STAFF REPORT

APPLICATION PRC B-846-02

PRC PROPOSAL: To approve the PRC Plan associated with Development Plan B-846, to construct a two-story parking structure with one level at grade and one level below grade.

Title of PRC Plan: PRC B-846-02 Reston Square Sheraton Garage
Prepared By: Urban Engineering & Associates, Inc.
Original and Revision Dates: November 2006 as revised through January 4, 2008

DECK PLANTER

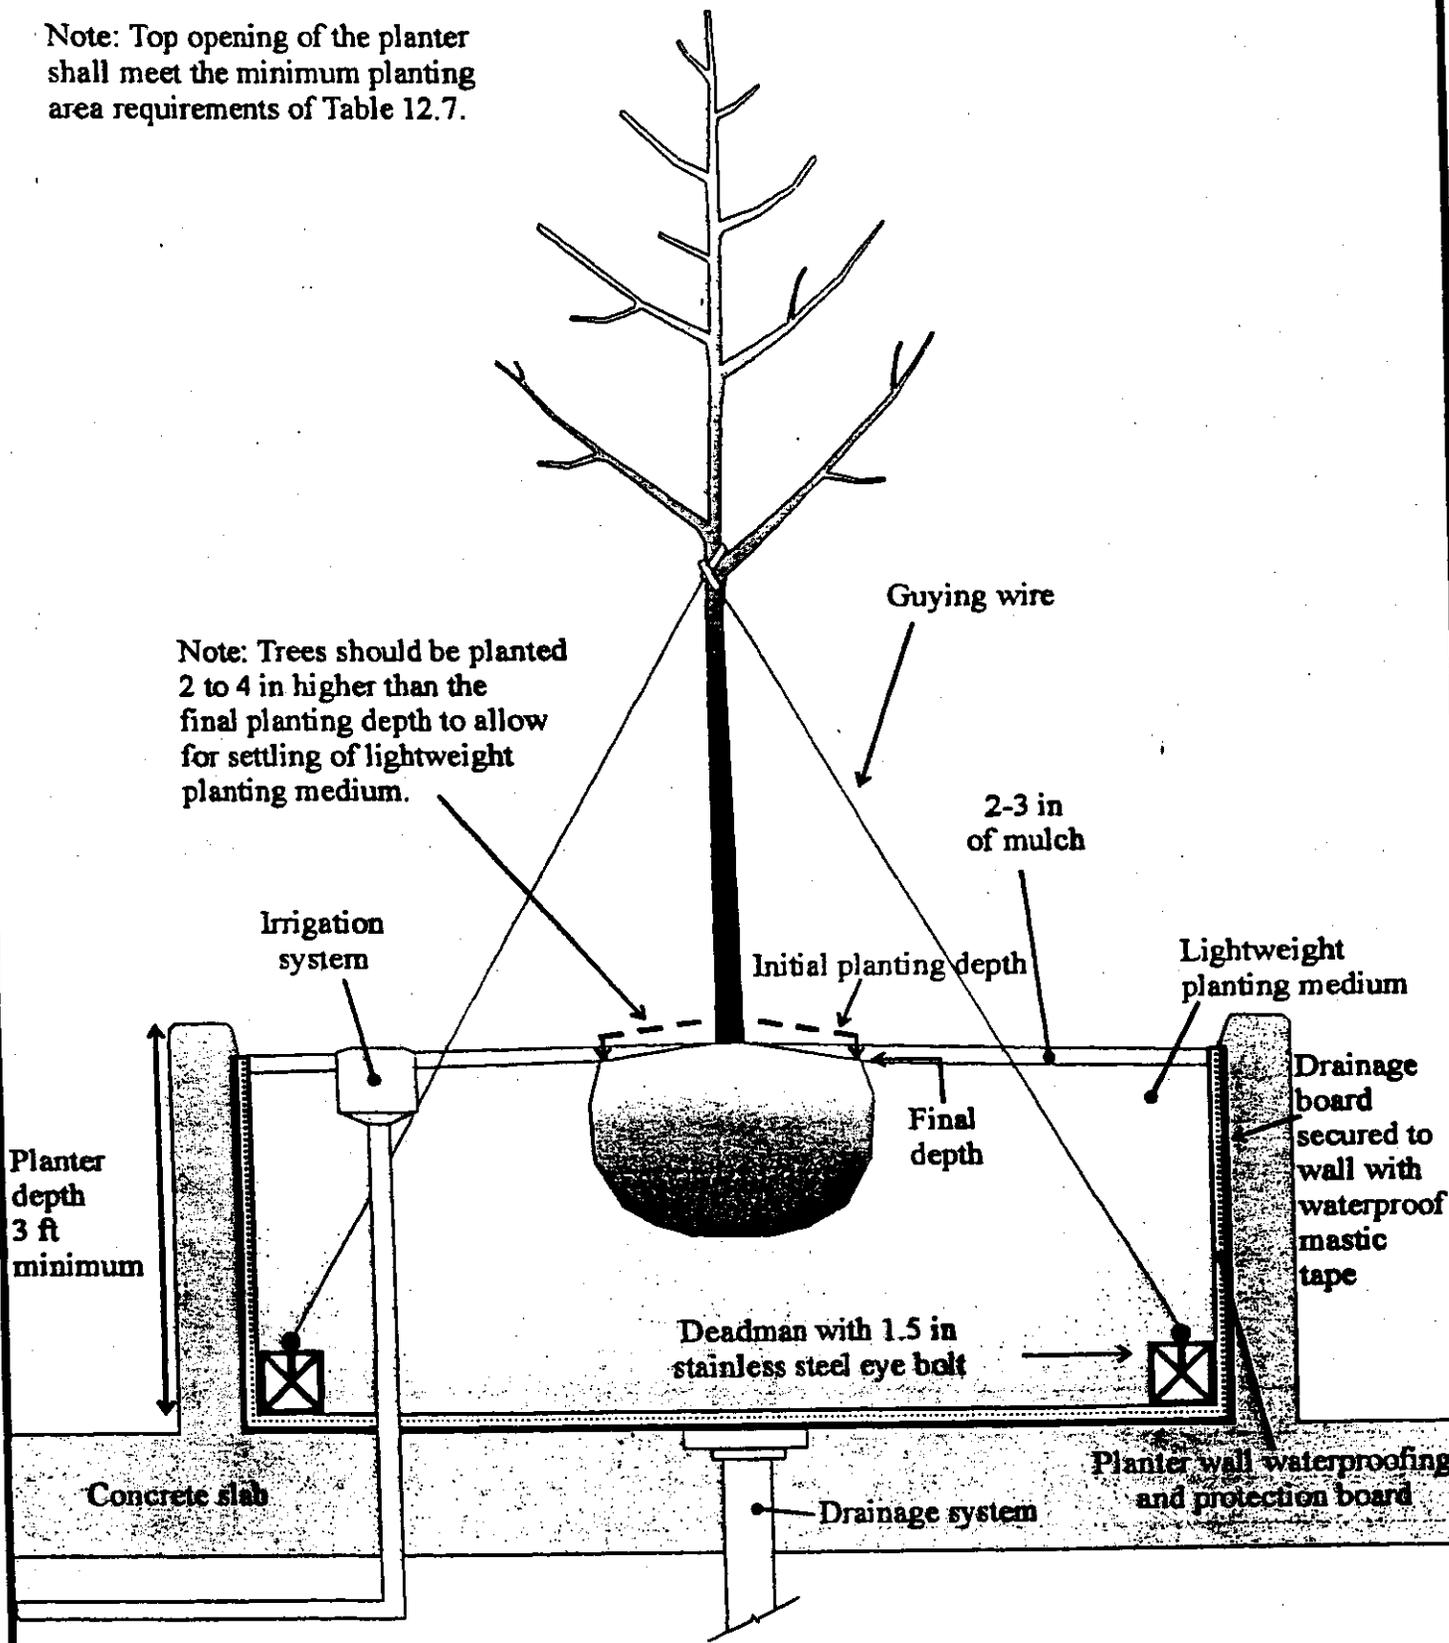
2. **Comment:** No planter detail is provided to show how trees proposed for the parking deck of the garage will be planted to ensure their long term survival.

Recommendation: Provide a detail similar to the attachment, that illustrates the overall size, depth, soil composition, irrigation technique, and drainage that will enhance the survivability of the proposed trees in the difficult conditions associated with parking decks.

2. A minimum of 36 inches of soil shall be provided where trees are shown to be planted over underground parking areas. A planter detail shall be provided for trees that are proposed to be planted on the parking deck of the garage, as determined by UFM, DPWES.
